Re:- Top Ryde Shopping Centre

Residential DA Buildings - Disability Access B & F & L3, 4 Car Parking. ¹

As requested we have carried out an evaluation of the proposed Residential areas, buildings B & F & Levels 3 & 4 car parking.

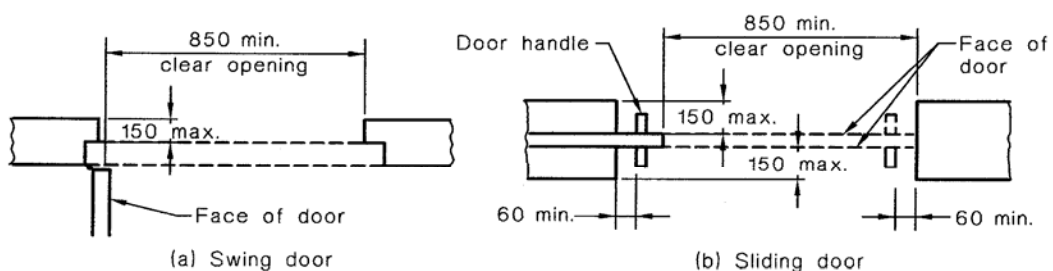
The DDA criteria for fire stair handrails illustrated below sets out an extension of the handrail from the first or last stair tread by the length of one going plus 300mm. This applies to all handrails whether they terminate on the landing in question or continue and should therefore be incorporated.

(g) Front approach—door opens towards a user

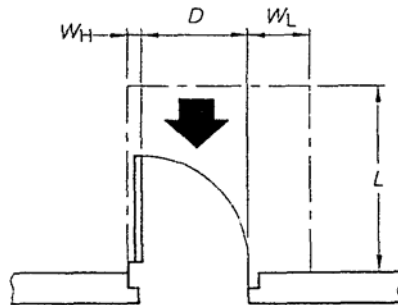
Doorways: Doorways along a path of travel to the apartments or facilities such as the double doors and those leading into the common rooms will all need to have the required minimum opening of 850mm for the first door leaf to be opened. A suitable solution would be the use of a $\frac{2}{3}$, $\frac{1}{3}$ or cat & kitten doors.

We also recommend the doors to the apartments are to allow for adequate circulation space, doorbells are to be located beside these entrance doors . No controls are to be within 500mm of an internal corner as people in wheelchairs in the majority of cases are unable to reach the control. Door bells will need to be set 500mm from an internal corner and 900mm to 1100mm above the FFL.
